SERVICE BULLETIN - TFA10-26-0020

Installation of AAE Cargo Fire Protection System (FPS) Placards and Suppression Harnesses on the B737-400 series aircraft equipped with the AAE FPS Kit Configuration B737-400(-1400)

Revision	Issue Date	Approved By
IR	January 12, 2015	<i>W. A. Euk</i>

AAE Cargo FPS Suppression Rack Installation (View Looking AFT)
For B737-400 aircraft that are equipped with AAE A/C Configuration (-1400)
 (Section shown above is from AAE Installation drawing TFC07-0062Q, Sheet 7, Rev. A dated 12/05/14)

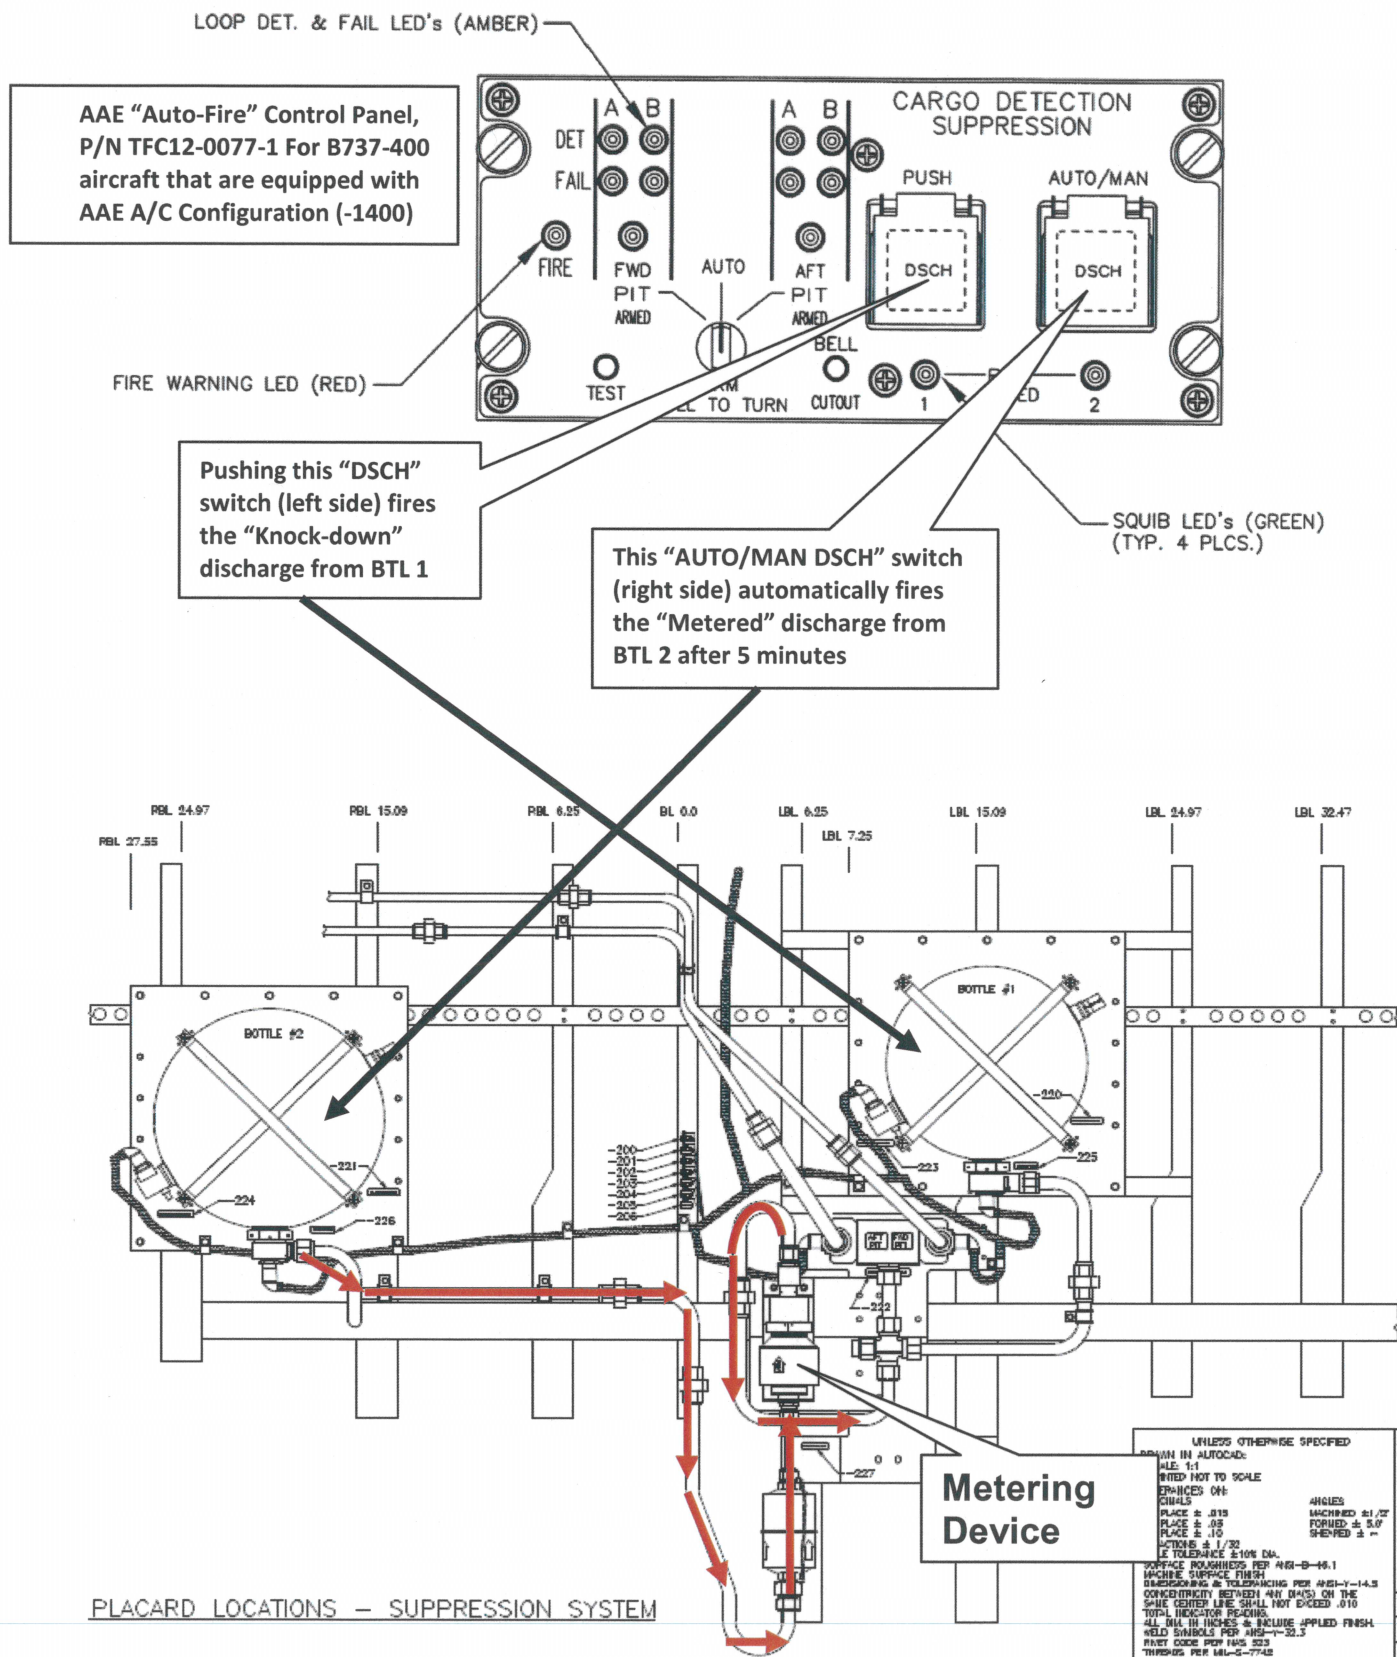
Upon review of AAE Installation Drawings TFC07-0062Q, “Class C Cargo Comp. FPS Placard Location Instructions”, Sheets 5, 6, and 7, it was found that, the callouts for the following placards are shown in the wrong locations.

- BOM Item No. -220 "BTL 1 Cargo Suppression", P/N TFC05-0044-36 is shown to be installed on BTL 2
- BOM Item No. -223 "BTL 1 Pressure Switch", P/N TFC05-0044-39 is shown to be installed on BTL 2
- BOM Item No. -225 "BTL 1 Squib", P/N TFC05-0044-41 is shown to be installed on BTL 2

- BOM Item No. -221 "BTL 2 Cargo Suppression", P/N TFC05-0044-37 is shown to be installed on BTL 1
- BOM Item No. -224 "BTL 2 Pressure Switch", P/N TFC05-0044-40 is shown to be installed on BTL 1
- BOM Item No. -226 "BTL 2 Squib", P/N TFC05-0044-42 is shown to be installed on BTL 1

Further, if it is verified that the placards were installed incorrectly, this may have resulted in the BTL 1 and BTL 2 Suppression Harnesses being mated to the Pressure Switch and Squib on the wrong extinguisher bottle, decreasing the ability of the AAE FPS Suppression System to provide enough extinguishing agent to put out a fire and keep it suppressed for the required duration of protection.

Note BTL 2, regardless of its location, is ***always*** the container that is connected to the metering device.

This Service Bulletin is intended to resolve the unsafe condition by providing the operator/maintenance personnel with step-by-step instructions on how to (1) inspect the AAE Cargo FPS Placards and Suppression Harnesses at the Suppression Rack Assembly to determine if they are installed correctly; and if they are not, (2) re-install new placards and suppression harnesses in a manner that will eliminate the current unsafe condition and remove the possibility of it reoccurring during future scheduled maintenance.

To accomplish this, it's important to understand that the 1st Extinguisher Bottle (BTL 1) of the AAE Cargo FPS always provides a “High-Rate Knockdown” agent discharge. And the 2nd Extinguisher Bottle (BTL 2) of the AAE Cargo FPS always provides a “Metered” discharge of agent to sustain the concentration of agent in the compartment for the required duration of protection. To help the installer/maintenance personnel understand, below is a photo of the “Auto-Fire” Cargo FPS Control Panel, P/N TFC12-0077-1, along with a diagram of the suppression rack installation for the B737-400 equipped with AAE A/C Configuration (-1400).

Figure 1. Bottle 2 Extension Harness

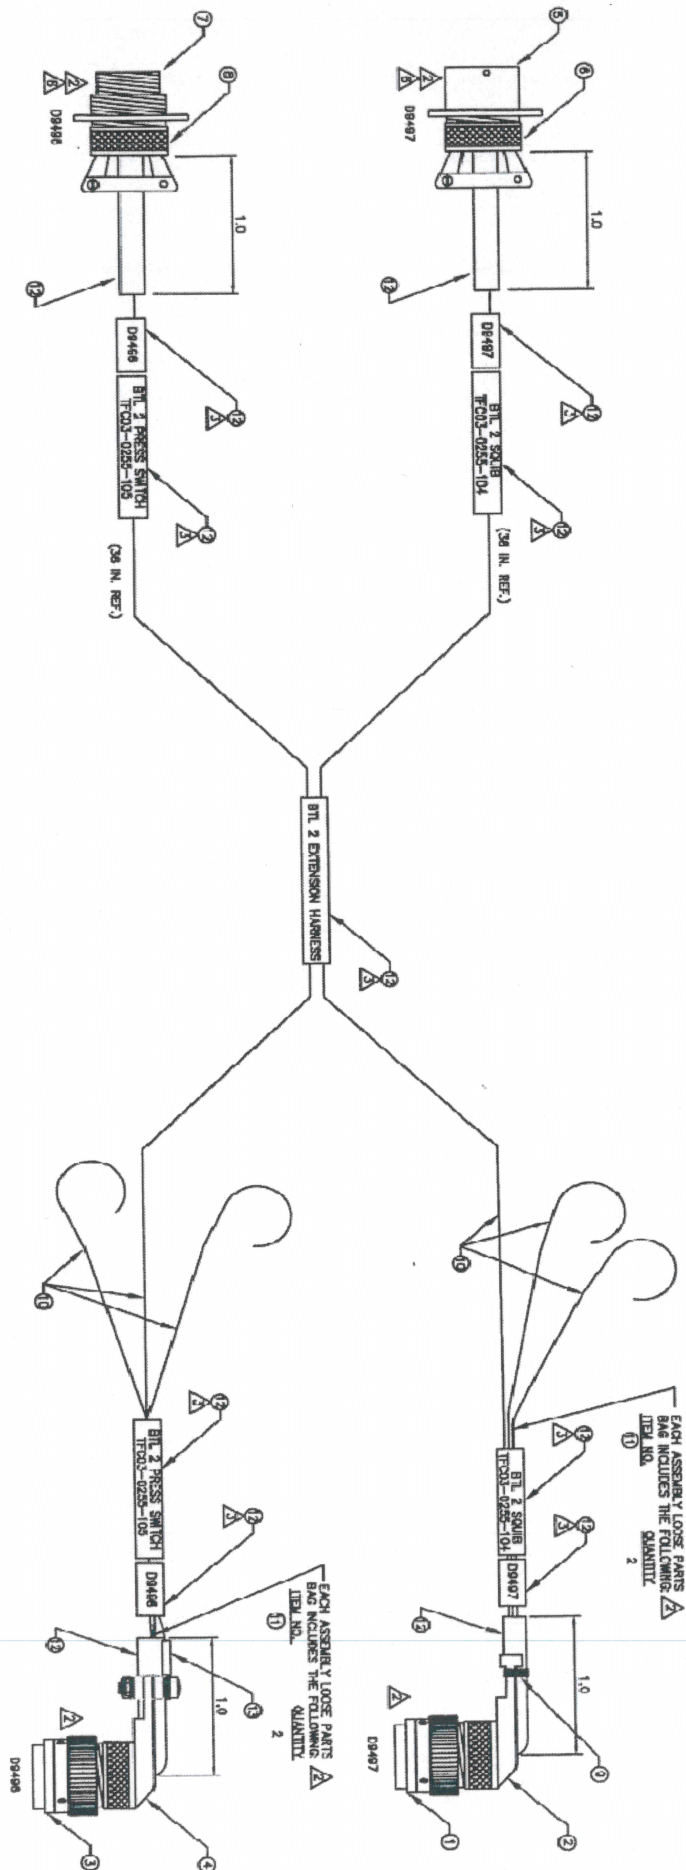
- a. The end of the extension harness, without the ground wires, is the end that will mate to the existing BTL 2 Pressure Switch and Squib Harnesses. The other end of the extension harness, with the ground wires, is the end that will mate to BTL 2's Extinguisher Container. See Appendix 1's Figure 1 for more details.

- ii. At the end of the BTL 2 Extension Harness are two sets of ground wires (W9448-001-20/ W9448-002-20 and W9449-001-20/W9449-002-20). See Appendix 1's Figure 1 for more details. Connect ring terminals, P/N 36154 to the ends of these ground wires. Route these ground wires to the existing ground studs and connect them as follows:

1. Bag Harness and label bag
2. Using the cut and marked wires identified in the appropriate list shown in Table 1 below, assemble the harnesses as shown. Terminate the wires in the connectors per Table 1 below. For wires and parts that are not terminated at time of build up (Loose Parts), bag these items separately and attach bags by the connector on the harness assembly. These loose parts will be installed at time of installation.

3. Identify harness with heat shrink label item No. 12 at connector ends per Table 2 below. Use 10 or 12 point Helvetica font, black letters on heat shrink label Item No. 12.

4. Bag and label loose parts by part number.
5. Perform a complete continuity test of wire terminations as shown by the wire list specified in Table 1 below. Verify each wire is electrically isolated (i.e. no continuity) from all the other wires in the assembly.

6. Install supplied heat shrink, P/N FIT221-1-1/2(CLR), qty 2, over the Bottle 2 Extension Harness connectors that attach to Bottle 2 Harness. Apply heat to shrink around connectors.
